# SR 125/SR 32 FOCUS AREA ADVISORY COMMITTEE MEETING NOTES

## MEETING #3 NOTES

August 20, 2018

#### Figure I-7C

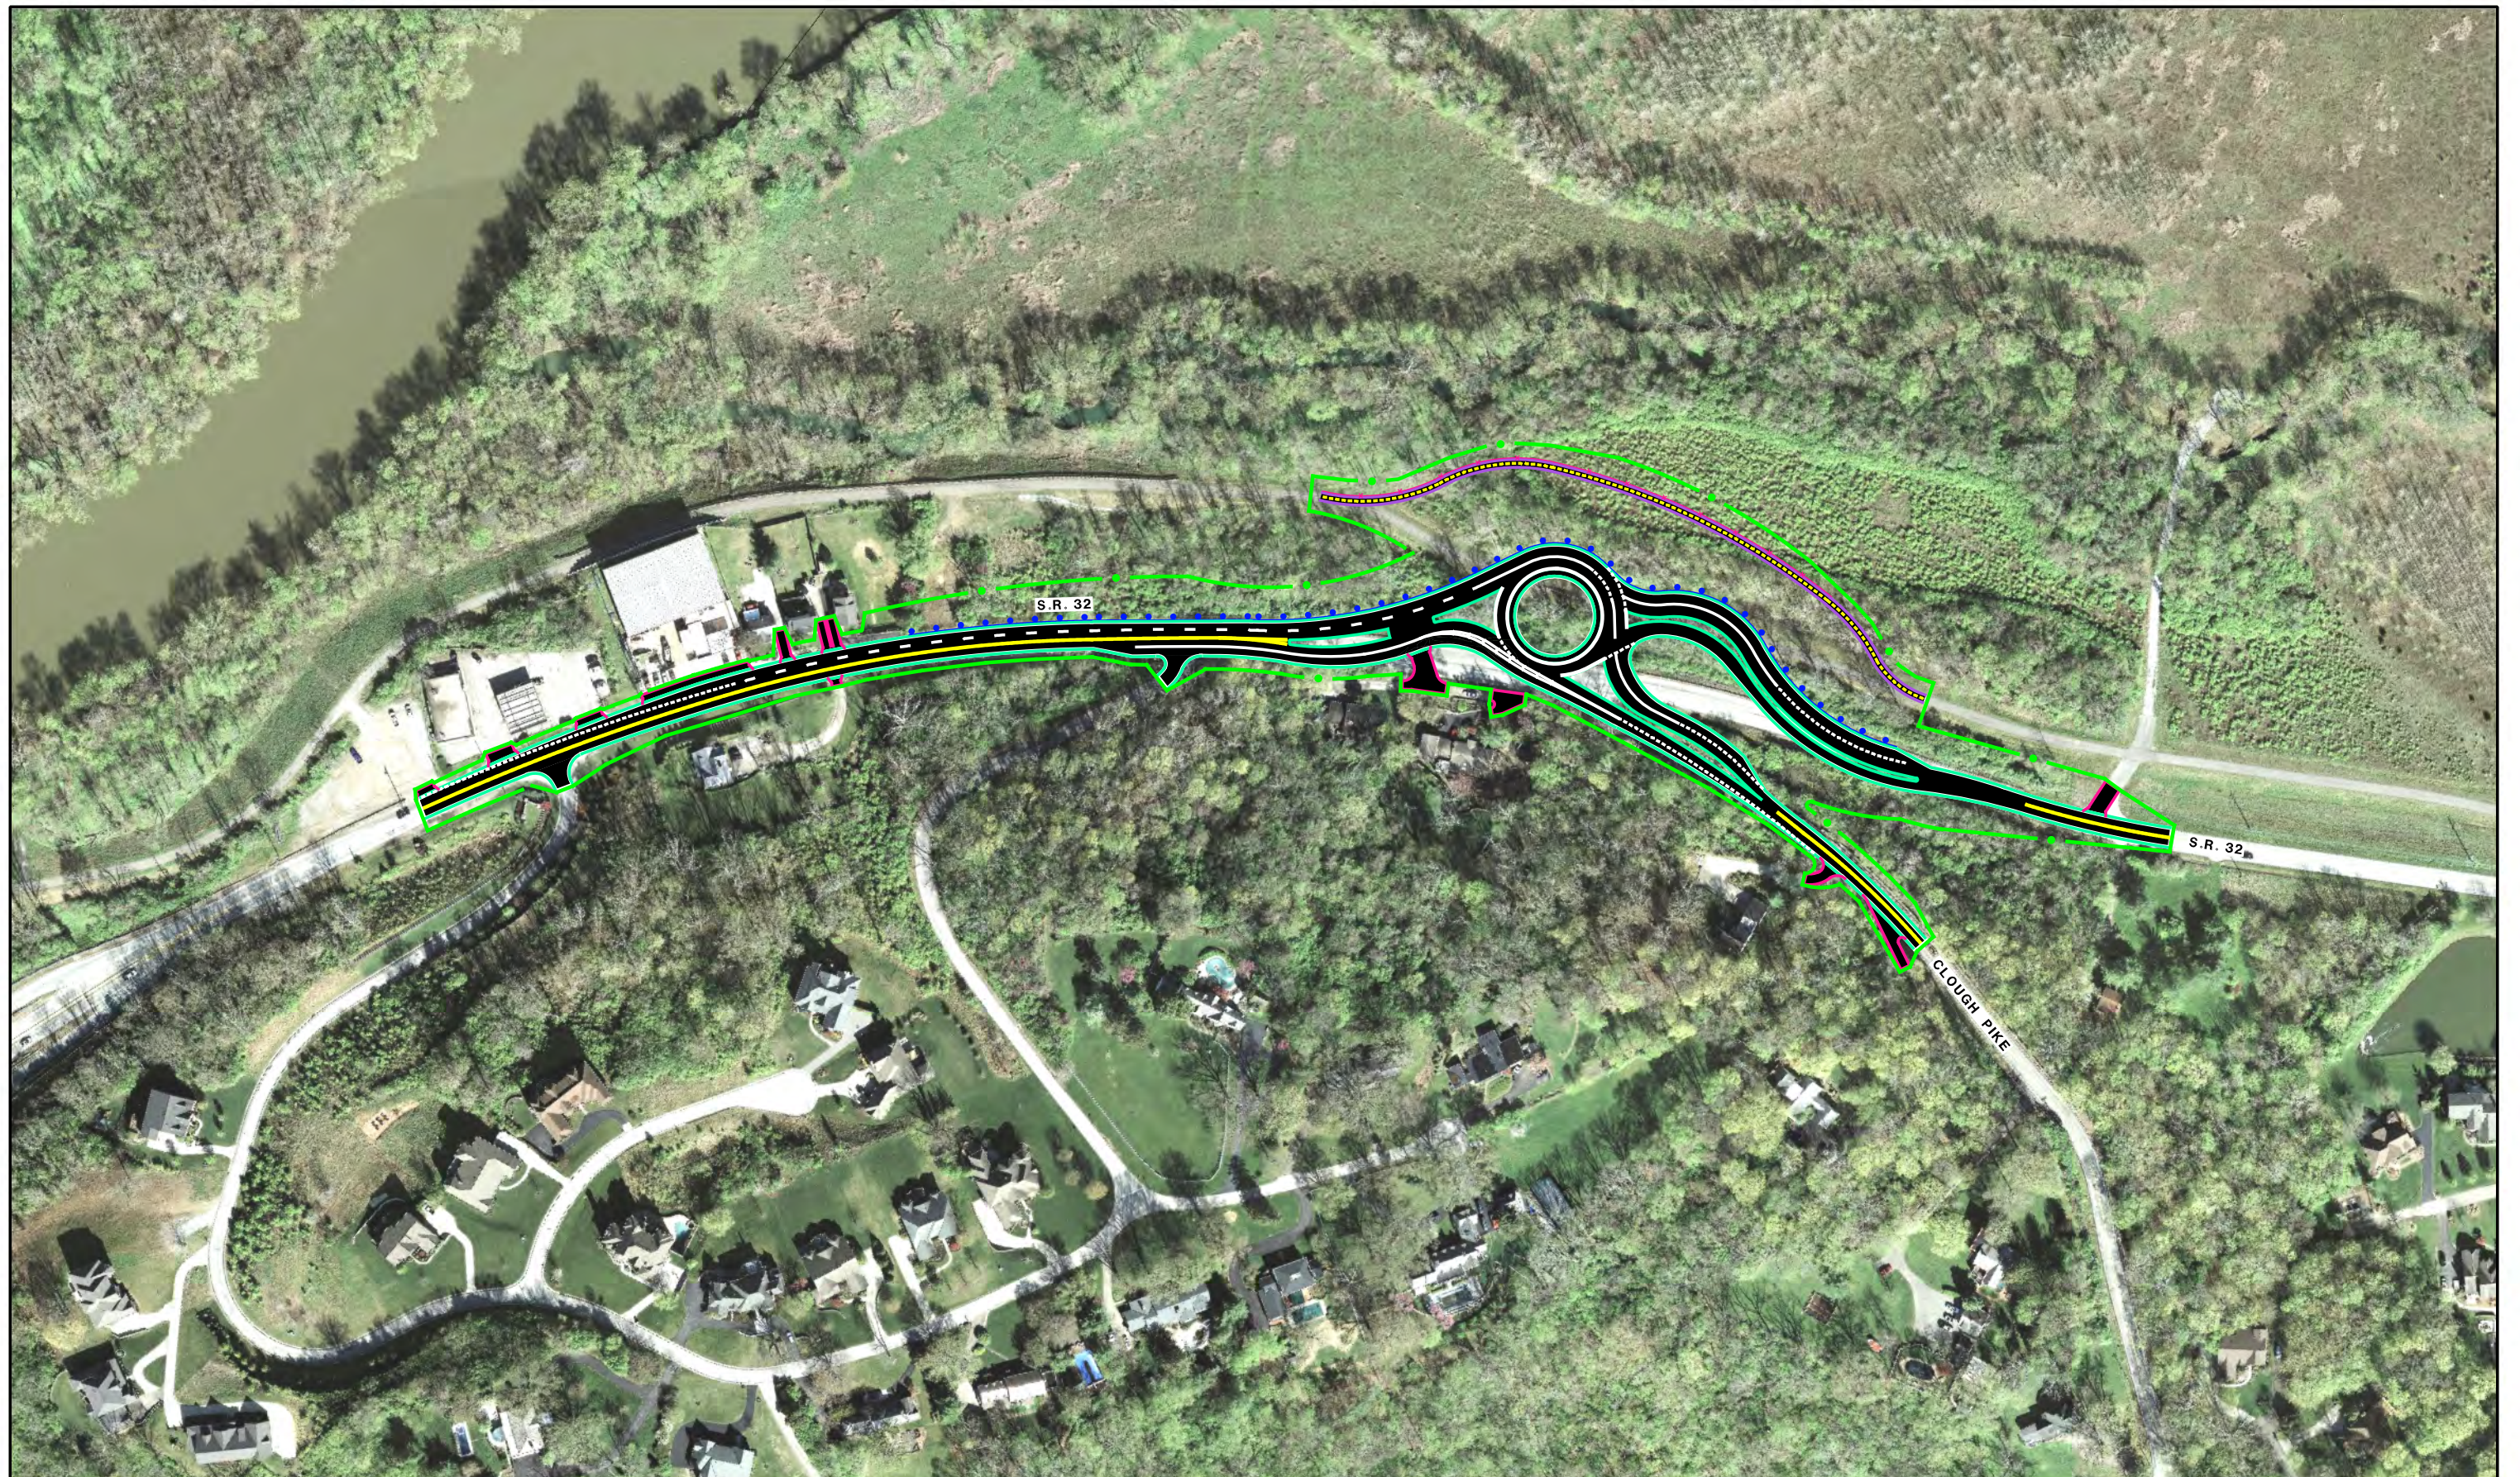
- The impacts of this concept are not that different from the flyover option.
- Roundabout is shifted north of the existing intersection so it could be positioned on flatter ground.

- The roundabout’s turning radius appears tight. However, it does allow trucks.
- Estimated construction costs of this concept and the flyover concept are similar (\$4.5M to \$6.8M for the flyover and \$3.8M to \$5.7M for the roundabout).

- No further study:
  - Concept I-7d achieves the same benefits at a lower cost.
  - The benefit/cost ratio appears lower compared to other alternatives.

**Figure I-7D**  
CLOUGH PIKE AND S.R. 32 GREEN TEE INTERSECTION

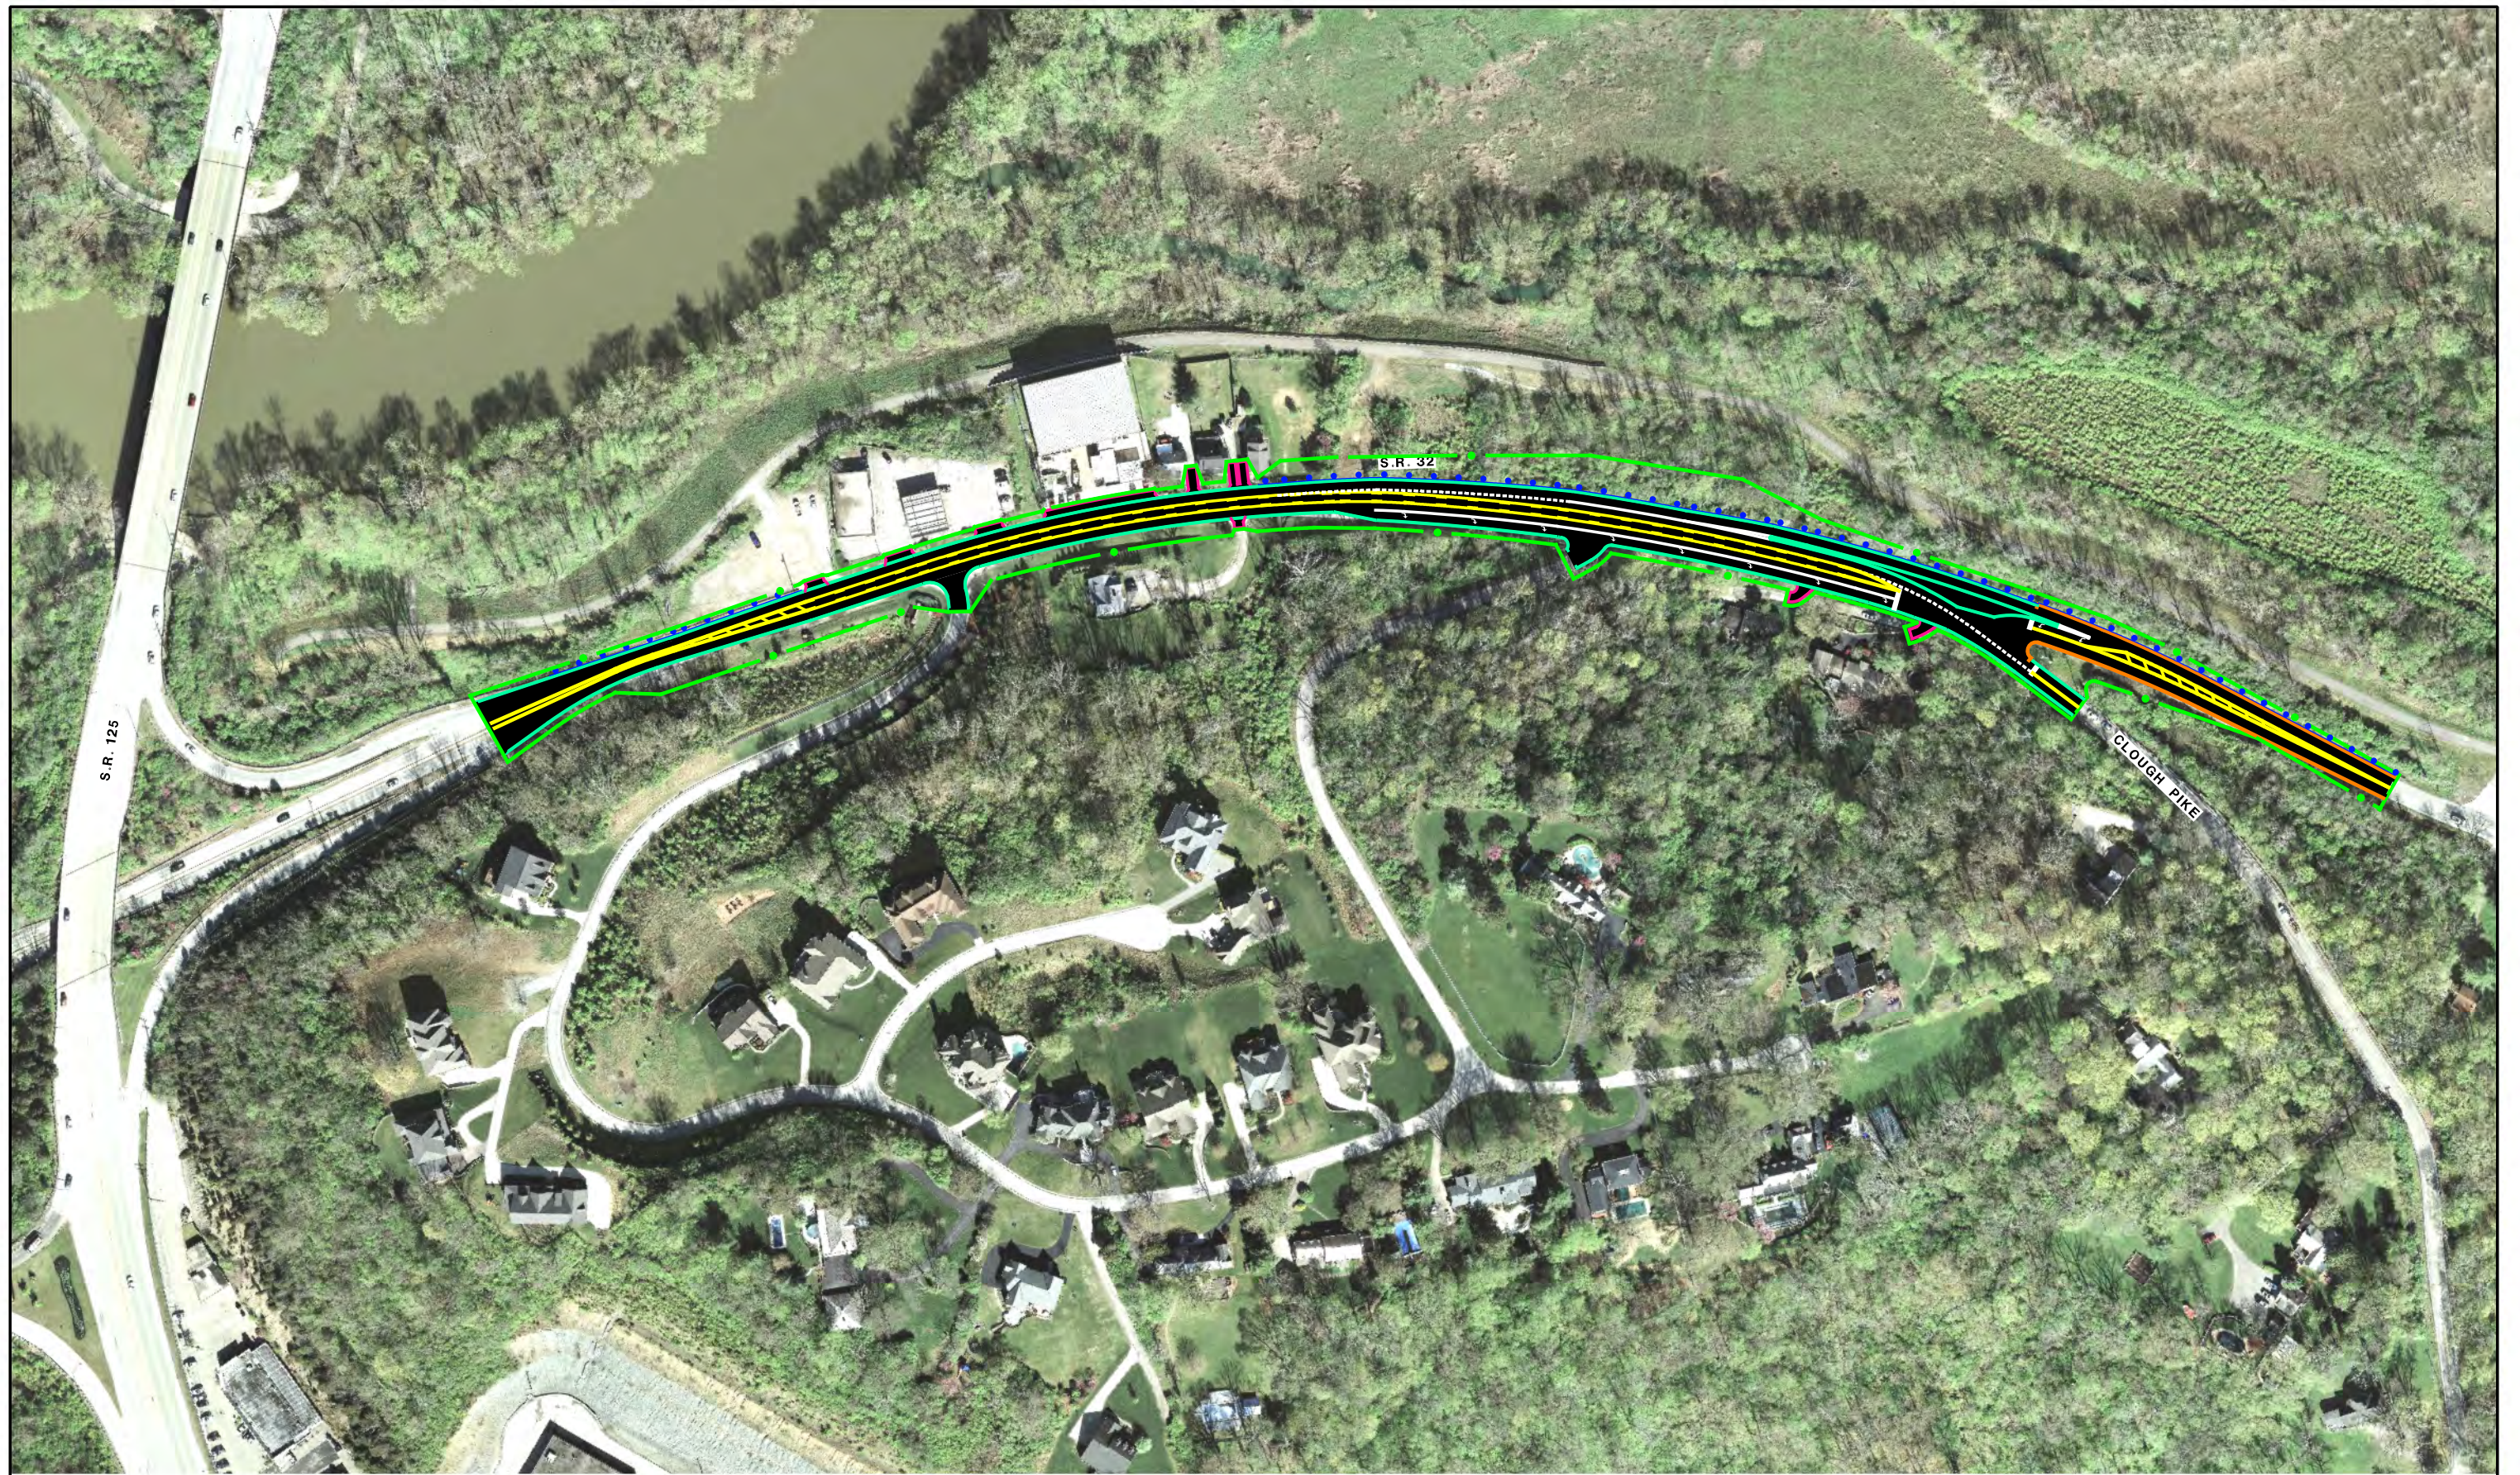
- This concept would permit a continuous flow of westbound traffic to SR 125 (similar to a roundabout). Westbound traffic turning left onto Clough would have to stop at the signalized SR 32/Clough intersection, but the turn would be permitted with this concept. Eastbound traffic would also have to periodically stop at the intersection.
- There are not many crashes at this location.

- (CONTINUED)
- Concept stays mostly within the footprint of the existing roadway unlike concepts I-7b and I-7c.
  - Simulations of the concept in operation showed that traffic flows well and there is enough room for vehicles to merge from Clough onto SR 32; concept meets ODOT’s typical design guidelines.
  - Improvements could be made to improve access to the pedestrian/bike trailhead located immediately west of Speedway. However, this trailhead was intended to be temporary, so access improvements may not be warranted. Further coordination with Hamilton County Parks regarding the status of the trailhead will be undertaken.
  - Based on simulation results, there appears to be a lot of benefit to this concept (similar to those offered by concepts I-7b and I-7c) but at a lower construction cost (\$1.6M to \$2.4M) than concepts I-7b and I-7c.

- Advance for public consideration.
- ODOT to double-check recommended design speed for westbound SR 32 in this area.
